19/04526/FUL October '19

**Chapel House Pipehouse, Freshford, BA2 7UJ.**

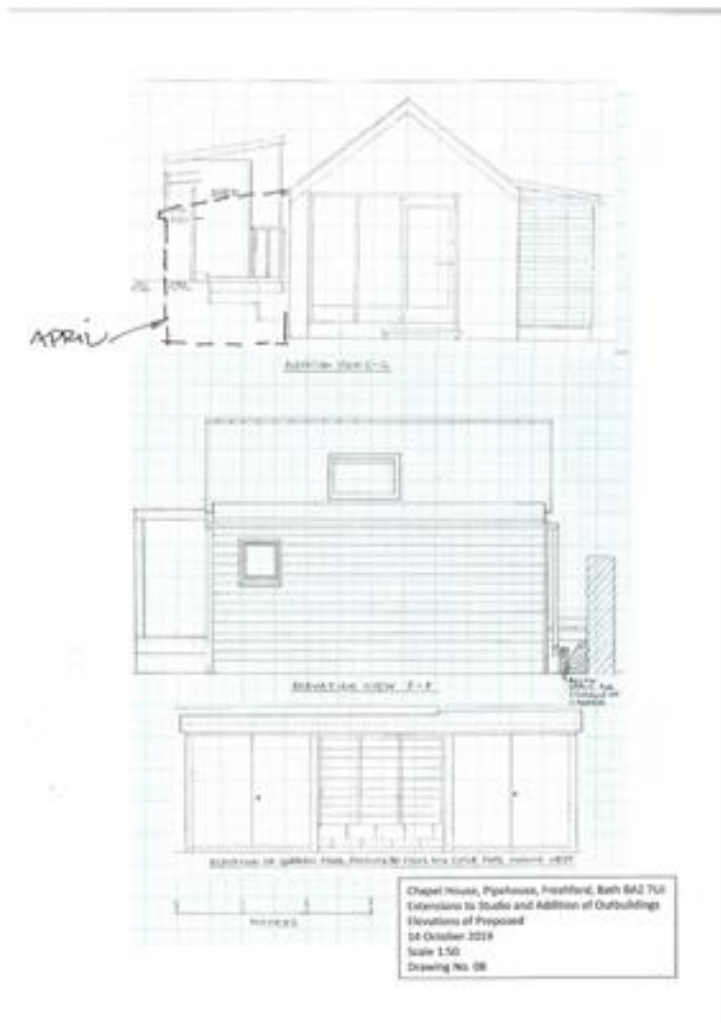
I believe the key difference between the proposals as above is; *'a reduction in the existing ground level on the western side of the existing studio'*

The reduction in ground level appears not to be happening now for whatever reason, I attach the elevations highlighting the difference, there is now an unhappy relationship between the main roof / tool shed and possibly some over bearing to the neighbour.

Comments only, essentially the council favour the resolution of the original proposals, and it would prefer to minimise the potential loss of any neighbour amenity and maintain (as consented) a less ad-hoc solution.
